**Re: Errata to Remedial Investigation and Feasibility Study (RI/FS) Work Plan, Revision 1; and Response to NDEP Comments dated April 25, 2014, on the RI/FS Work Plan, Revision 1; Nevada Environmental Response Trust Site, Henderson, Nevada (NDEP Facility ID #H-000539)**

**Responses to NDEP Comments Dated April 25, 2014  
Remedial Investigation and Feasibility Study Work Plan, Revision 1,  
Nevada Environmental Response Trust Site, Henderson, Nevada**

**Remedial Investigation and  
Feasibility Study Work Plan  
Revision 2**

**Remedial Investigation and Feasibility Study Schedule**  
 Nevada Environmental Response Trust Site  
 Henderson, Nevada

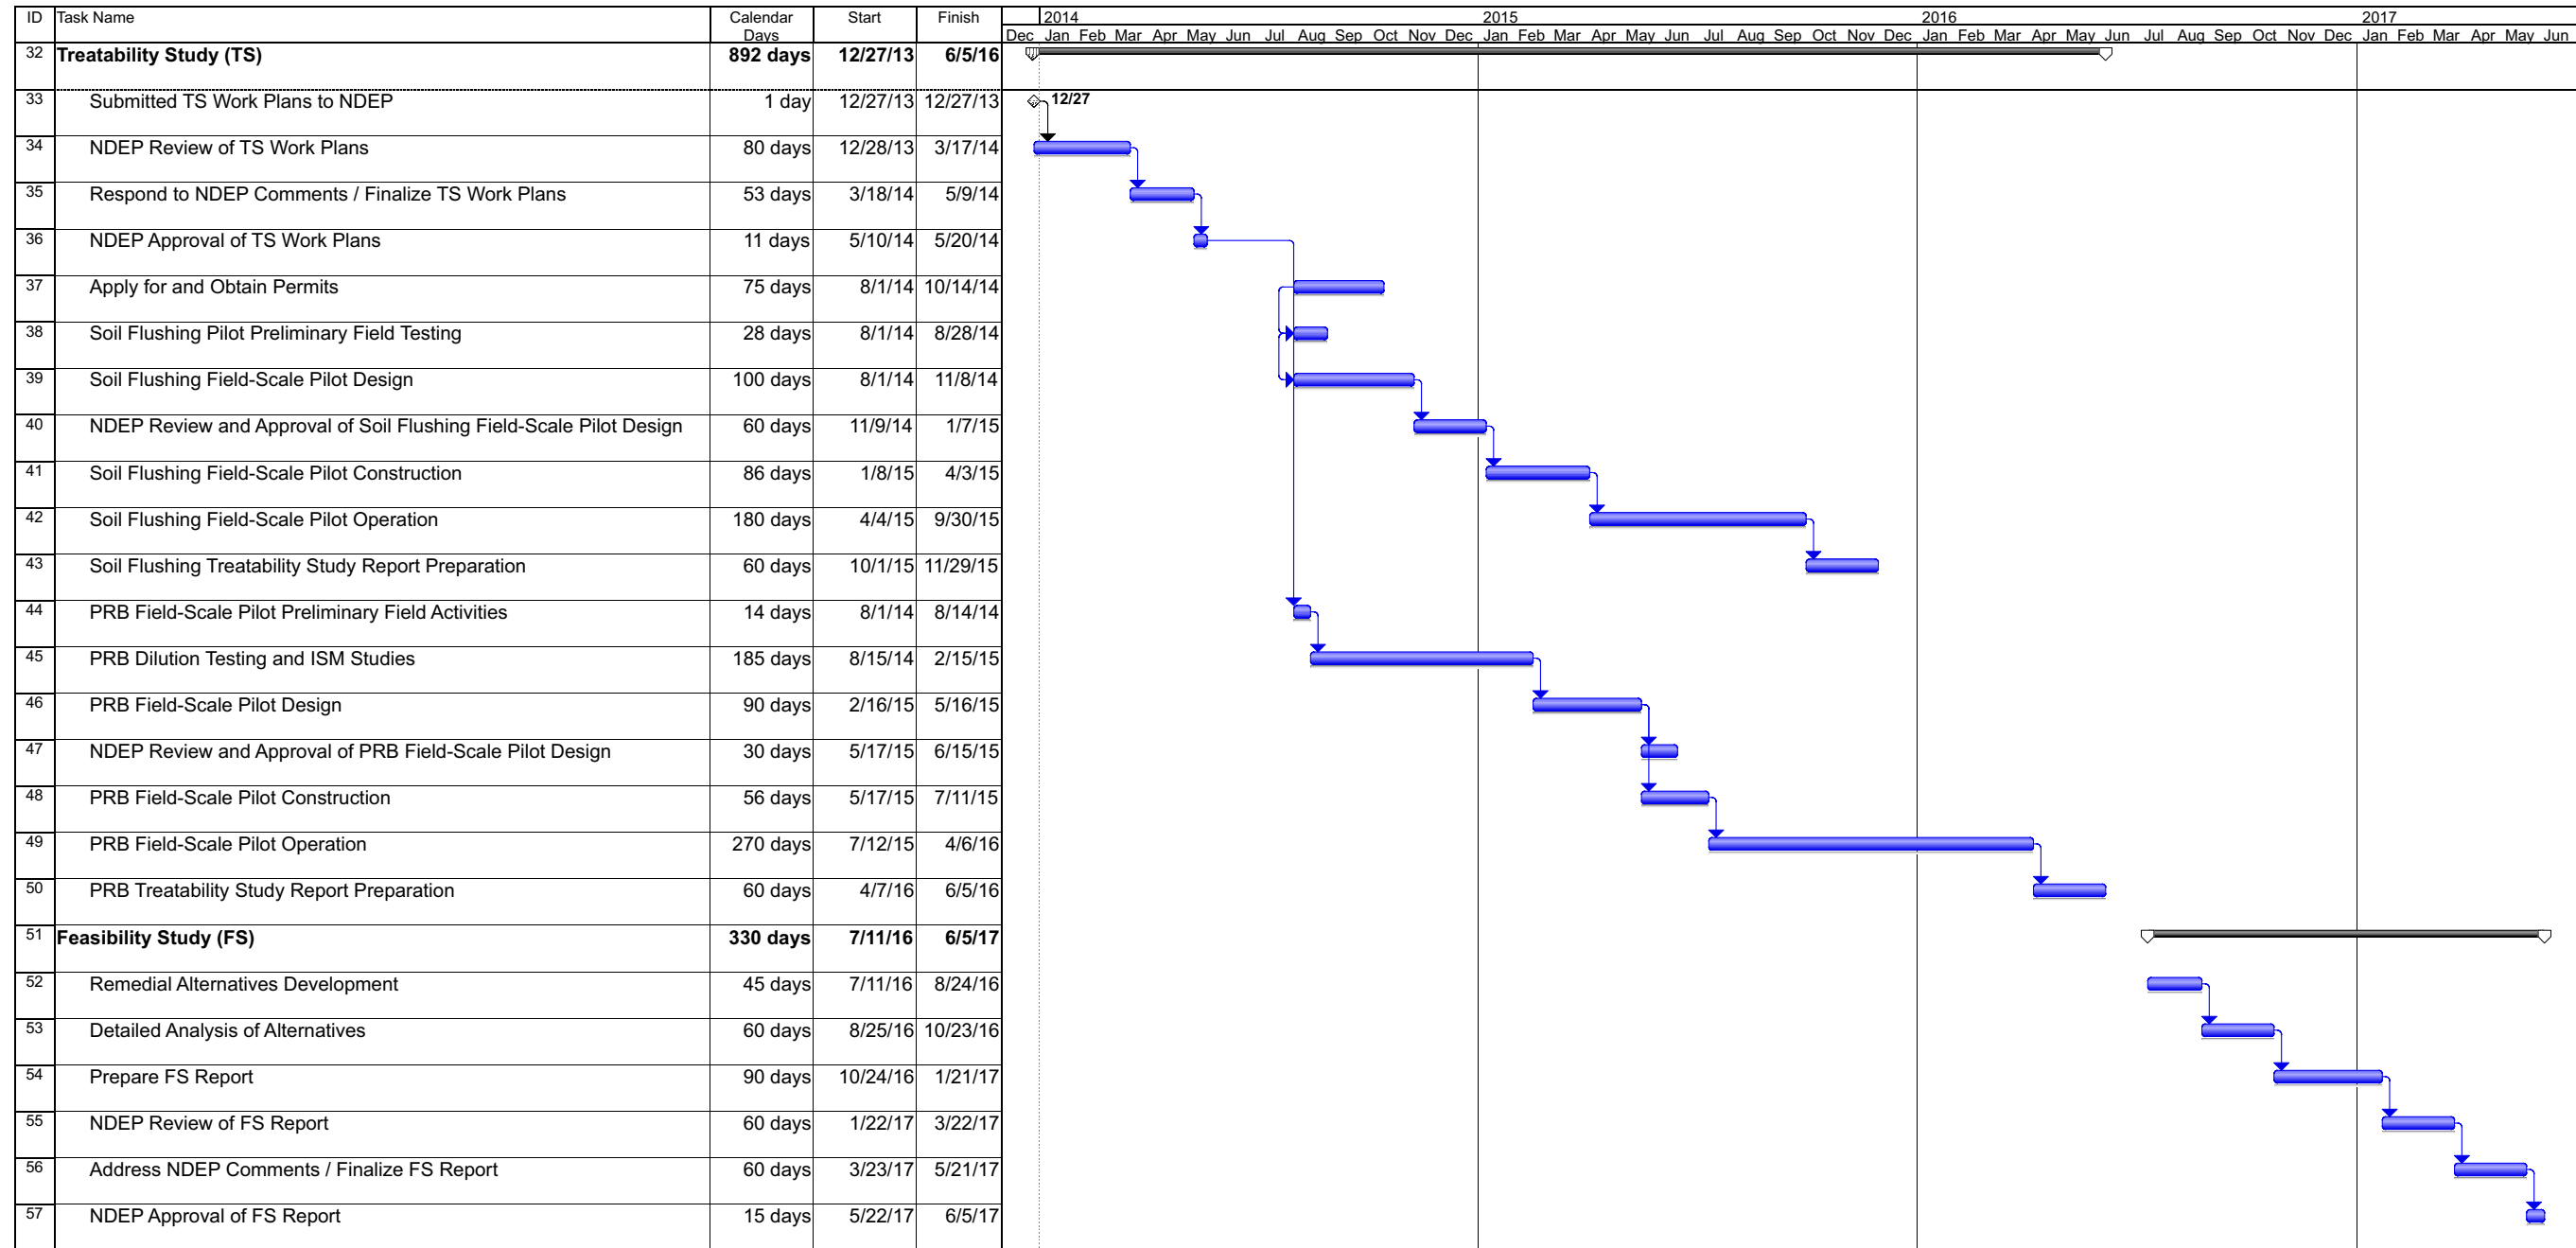
- Revised Figure 7-1 to provide an updated anticipated RI/FS project schedule
- Revised Title Sheets for tables, figures, plates, and appendices with updated headers and footers for revision number and report date
